BEFORE THE ARIZONA CORPORATION COMMISSION

DOCKET NO. W-01445A-05-0700  
DOCKET NO. W-01775A-05-0700

**REQUEST FOR:**

- (A) DETERMINATION OF COMPLIANCE  
WITH DECISION AND ORDER; OR  
(B) IN THE ALTERNATIVE, FOR  
ADDITIONAL TIME FOR COMPLIANCE  
FILING

**Figure 1 – Simulated Northwest Boundary per Model Layer**

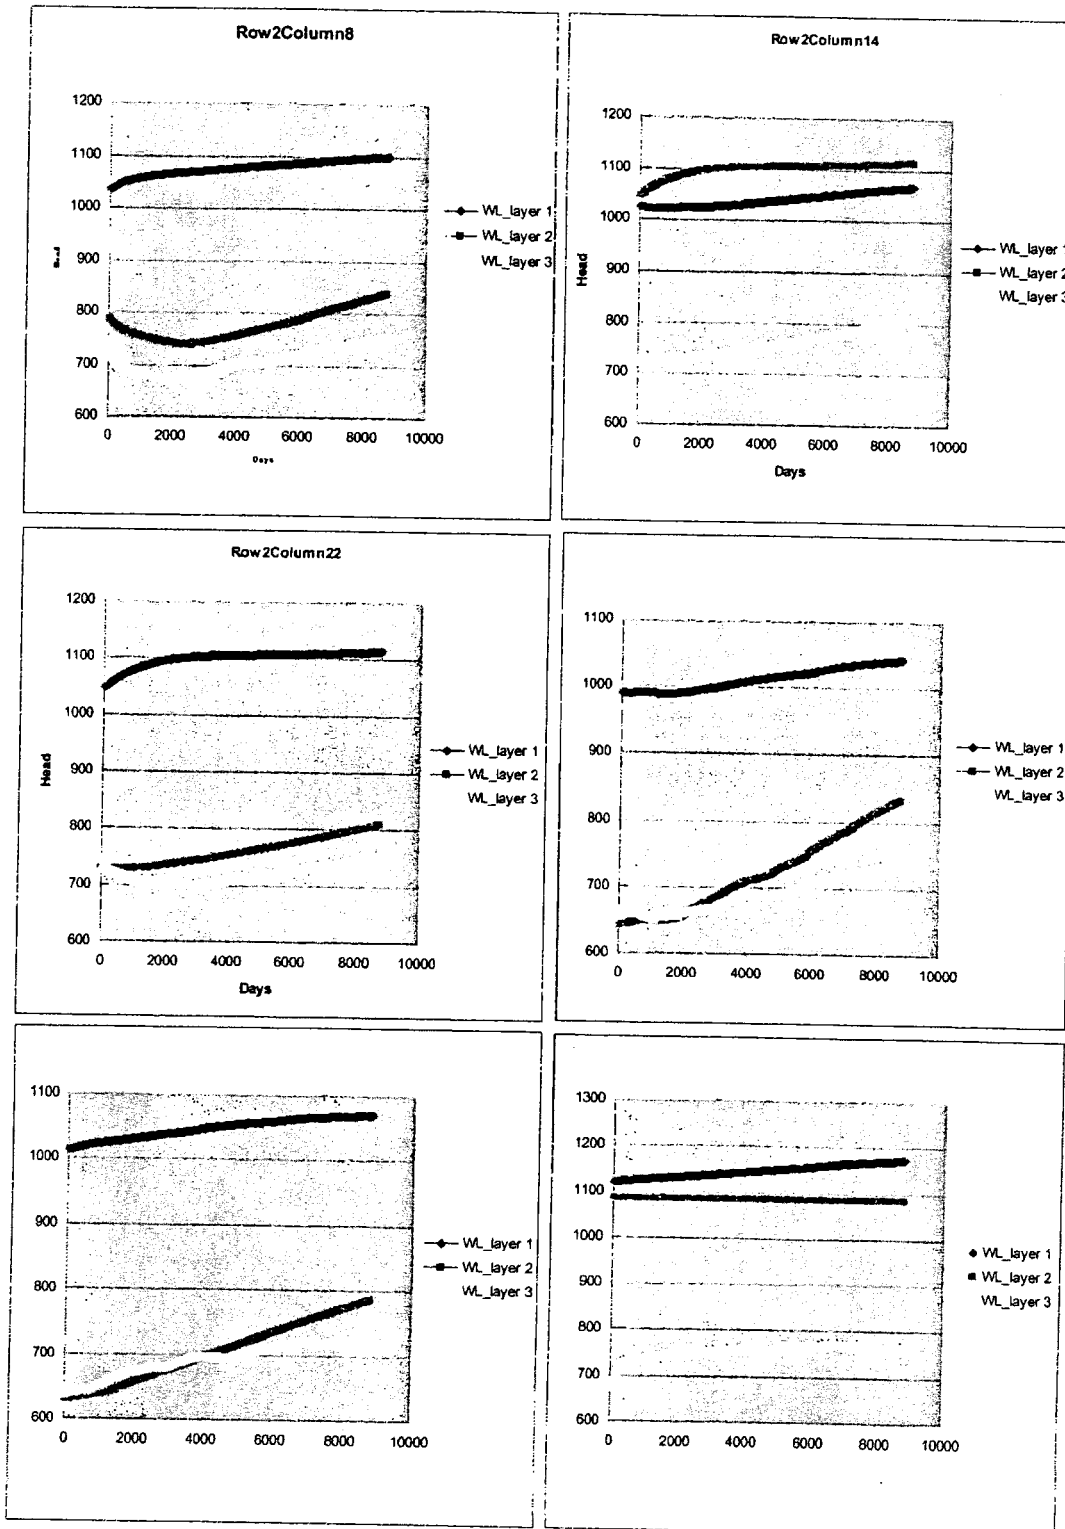
Groundwater underflow was simulated in the revised AWC model through a combination of general head boundaries, constant flux boundaries and recharge boundaries. The following address the comments regarding each type of boundary condition simulated in the model.

Groundwater underflow from the South Picacho Peak and the Cactus Forest were simulated through constant flux boundaries. In the 100-year projection model, these two groundwater underflow components (i.e. 24,000 AFY (acre-feet per year) in total) were diminished since 2030 (stress period 24, the same number of stress period used in the transient calibration model). The applicant must explain if this is a data input error or provide evidence to support the diminished groundwater underflow of these two areas.

**Figure 2 – Components of Agricultural Recharge within re-submitted AWC Model**

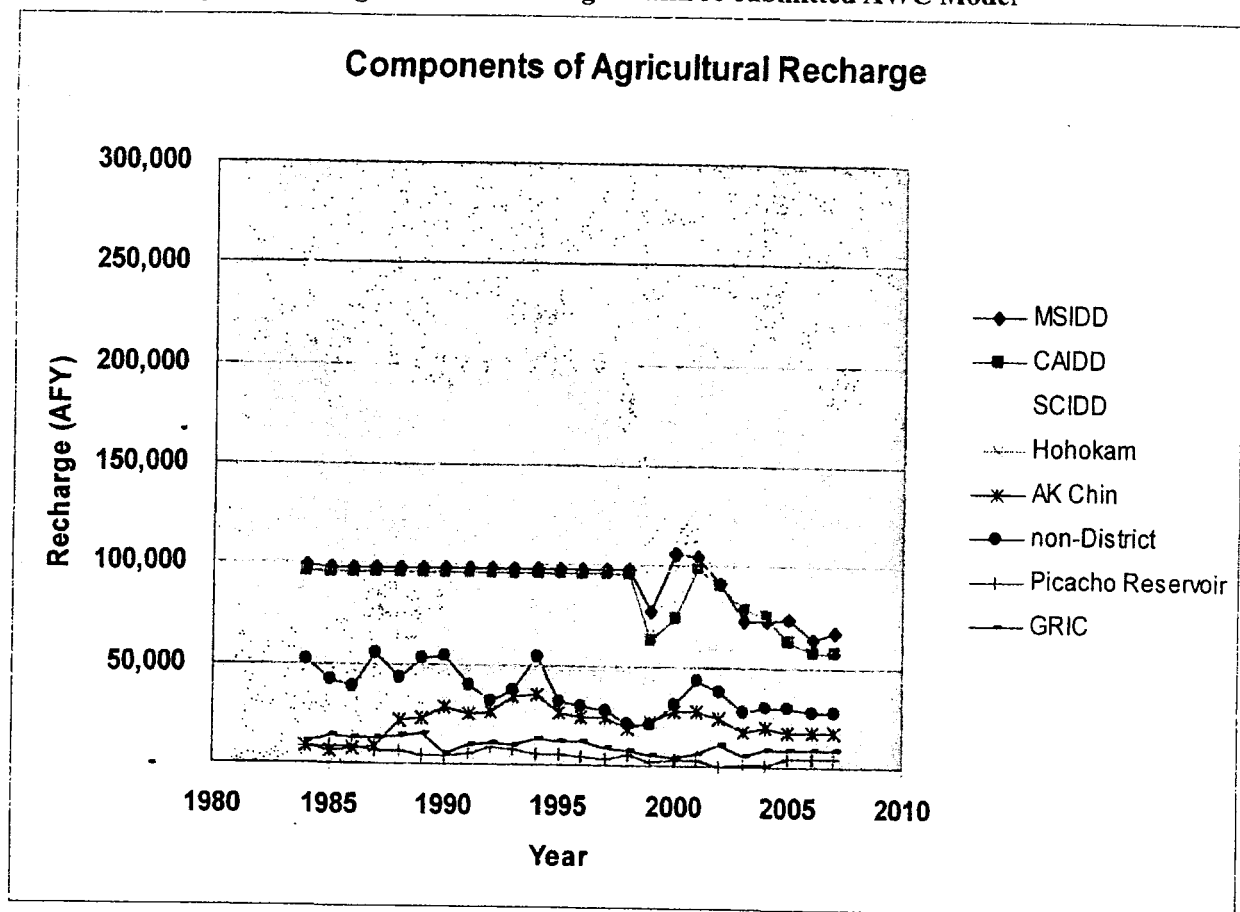
By accounting for the impact of the agricultural recharge lag time, which is assumed to be 20 years in the revised modeling report, the agricultural recharge was increased significantly. The agriculture recharge simulated in the revised model ranges from 261,707 AFY to 574,053 AFY. When the lag time is not considered, the conceptual agricultural recharge reported in the previous AWC modeling report ranges from 204,717 AFY to 377,129 AFY. The maximum increase of agriculture recharge was as much as 301,126 AFY in 1993. Initial estimate of the agricultural recharge by considering a 20 year lag time ranges from 198,000 AFY and 468,400 AFY. The calibrated agricultural recharge exceeds the initial estimate for all the years of the transient model (1984~2007). The agricultural recharge was over simulated and must be re-conceptualized.

A constant agricultural recharge was simulated for SCIDD, CAIDD, MSIDD, and HOHOKAM from early 1980s to 1998. After 1998, the estimated agricultural recharge for each of the irrigation districts started to fluctuate. The applicant is required to include discussions in the report to address this temporal recharge distribution (see Figure 2).
